Shoreline Setback Variance  
Chapter 343, Hawaii Revised Statutes  
Environmental Assessment (EA)/Determination  
Finding of No Significant Impact

Landowner/Applicant : Bruce E. Clements  
Agent : Analytical Planning Consultants, Inc.  
Location : 68-003 Laau Paina Place - Waialua  
Tax Map Key : 6-8-9: 11  
Request : Shoreline Setback Variance  
Proposal : After-the-fact approval to retain a Concrete Rubble Masonry (CRM)  
seawall  
Determination : A Finding of No Significant Impact is Issued ✓

FINAL ENVIRONMENTAL ASSESSMENT FOR A  
SHORELINE SETBACK VARIANCE APPLICATION

**EXISTING SEAWALL**

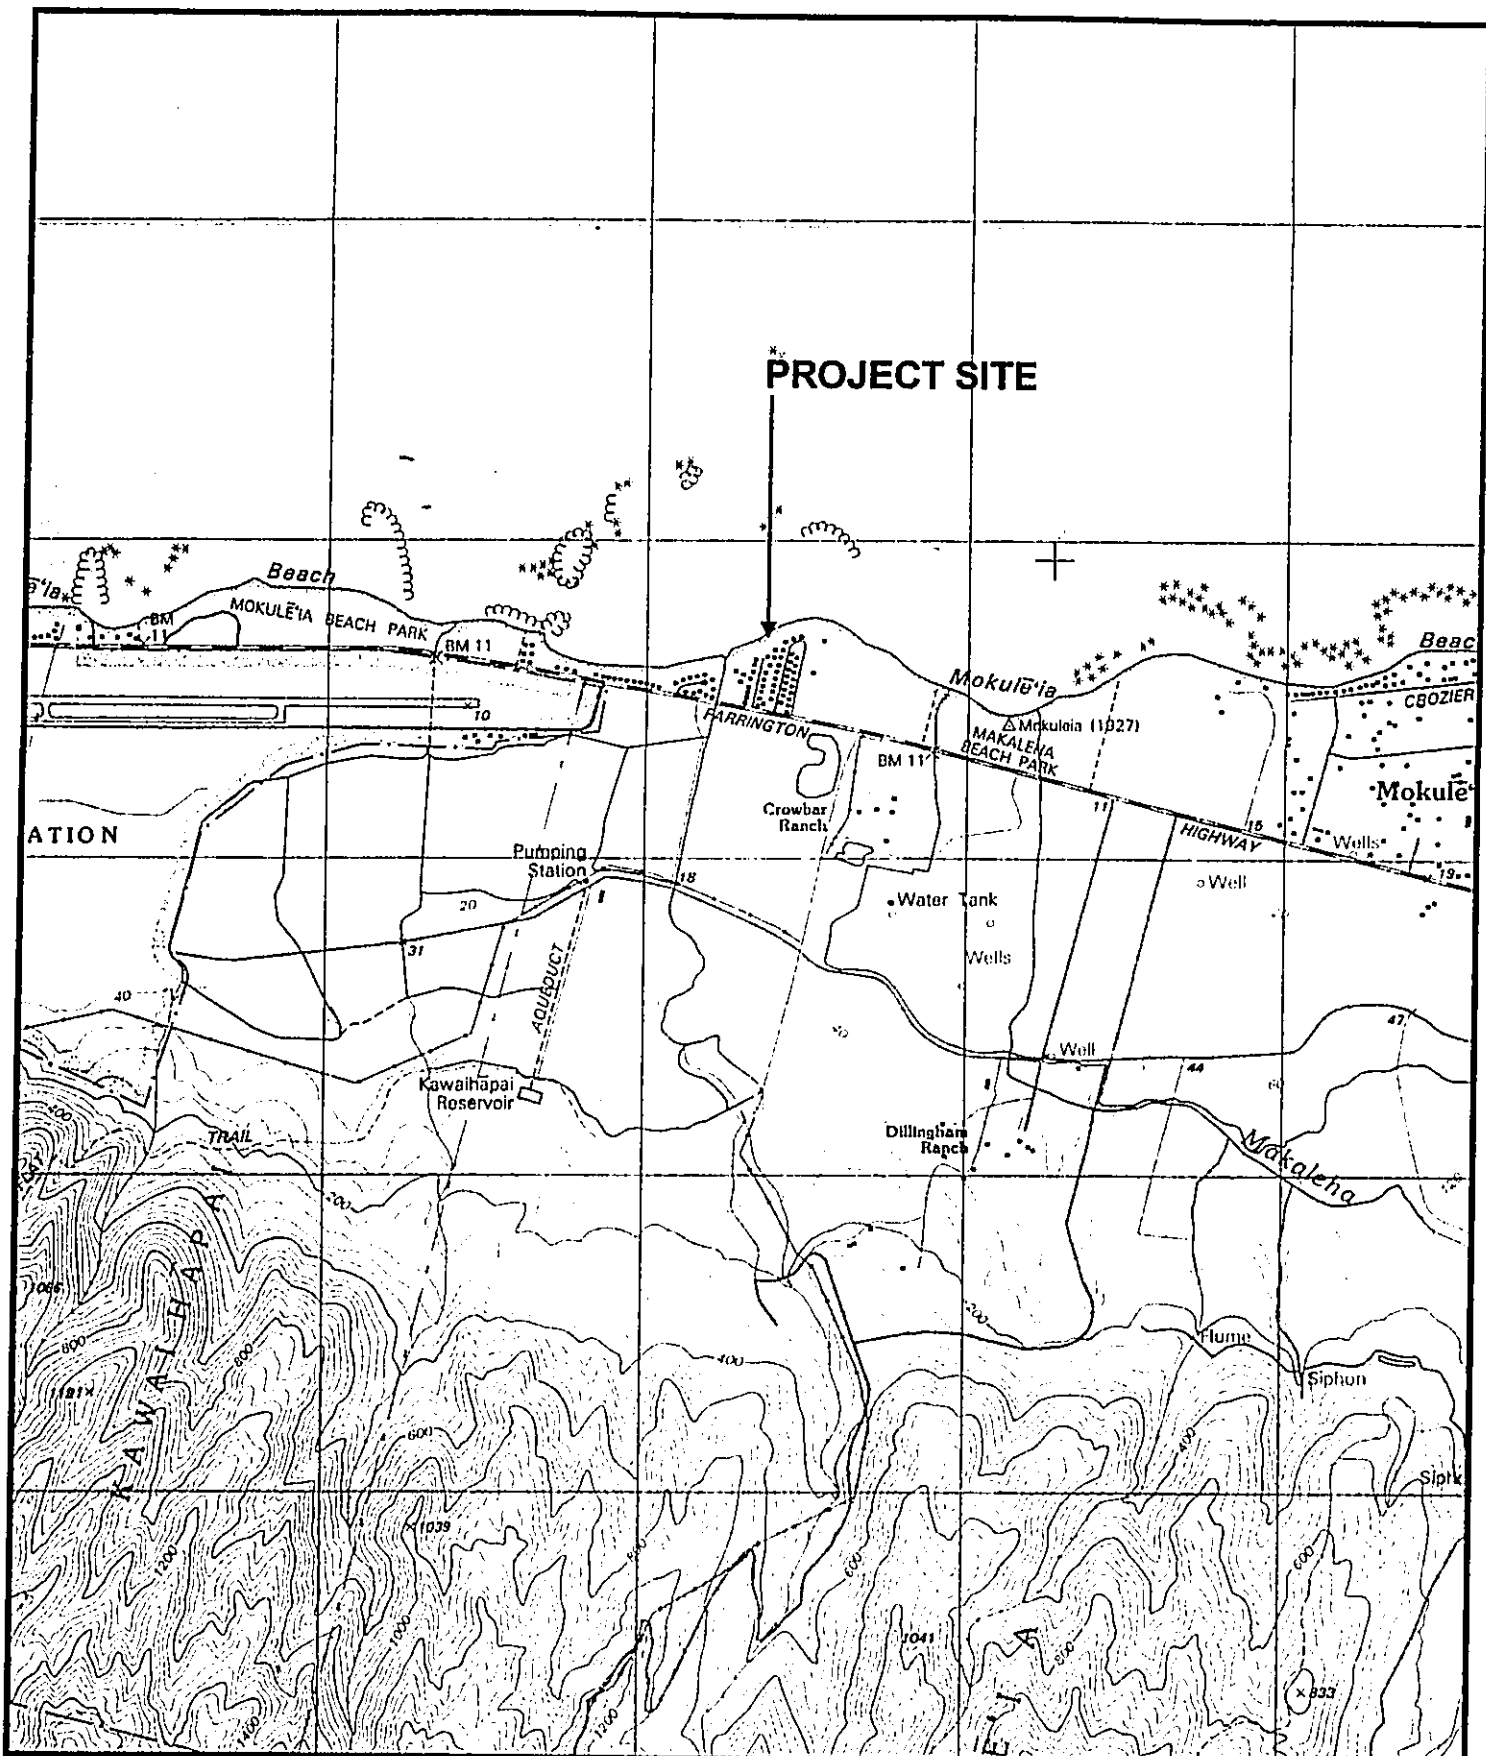
1. Section 2.1, Location, page 3: We note that there is right-of-way or easement, Tax Map Key: 6-8-9: 21, along the property's west boundary depicted in Figure 2, page 5. Please clarify the function of this easement. Is the easement privately owned or is it being utilized by the public as an access way to the shoreline? If it is a public right-of-way, discuss the impacts of the CRM wall on public pedestrian access to the shoreline. In addition, please provide more details of the subject property (e.g., topography).

1. **Section 2.1, Location, page 3.** There is a privately owned right-of-way TMK 6-8-9: 021 along the subject property's west boundary. It provides access to the beach from Laau Paina Place. It is jointly owned by the property owners on Laau Paina Place and is not open to the public. There is a public right-of-way off of Hoomana Place, just west of the stream. The topography of the subject property is relatively flat. This additional information has been added to the Final EA.

Figure 7A  
 SEA WALL ELEVATION

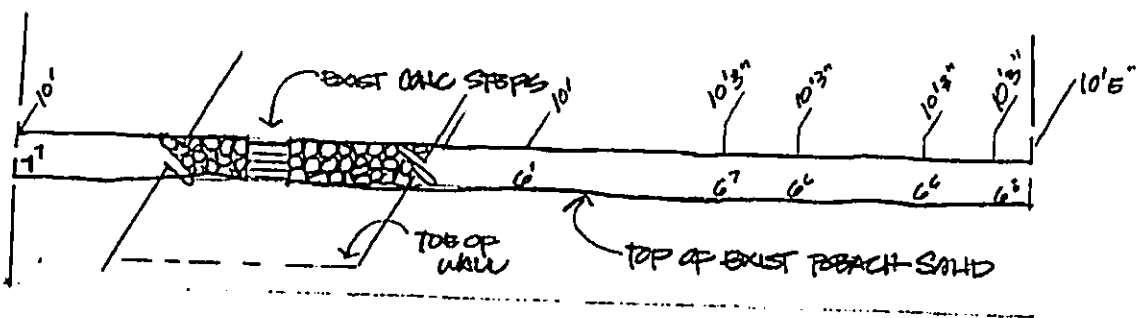
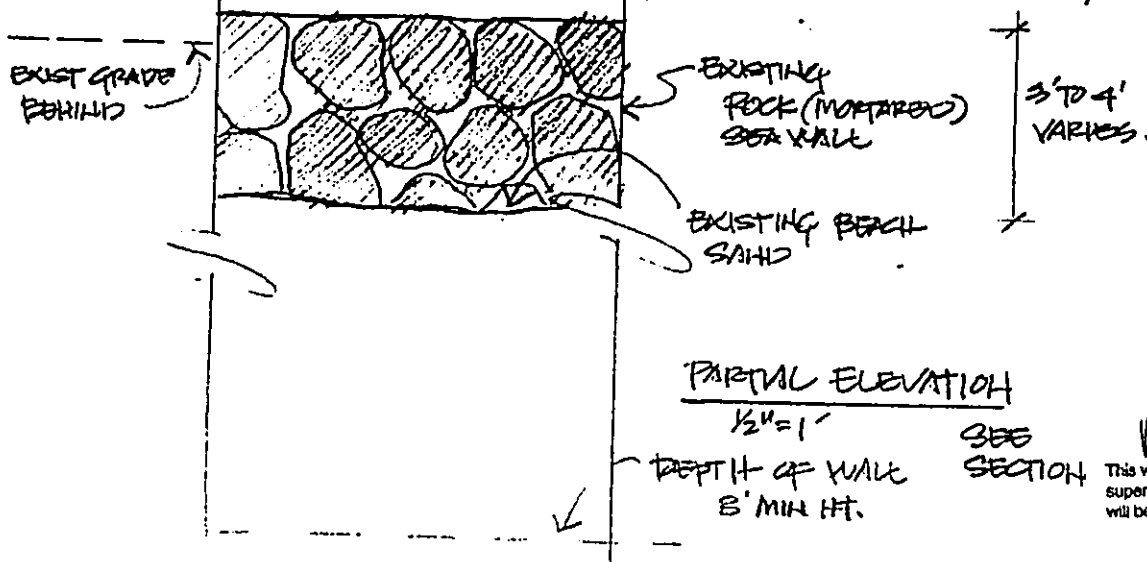
3. Section 2.3, Proposed Action, page 6: Inasmuch as the applicant is seeking approval of a shoreline setback variance, please expand your discussion on the status of the acquisition of a current certified shoreline survey. In addition, provide elevation drawings (dimensioned) of the subject CRM wall.

3. **Section 2.3, Proposed Action, page 6.** A shoreline survey was conducted by licensed surveyor Jamie Alimboyoguen on February 4, 2004 and was then submitted by him to the Department of Land and Natural Resources on February 18, 2004. It is anticipated that a determination by the Board of Land and Natural Resources should be forthcoming by the end of May 2004. It is understood that a certified shoreline survey is required for the Shoreline Setback Variance application. An elevation drawing with dimensions of the seawall is provided in the Final EA.
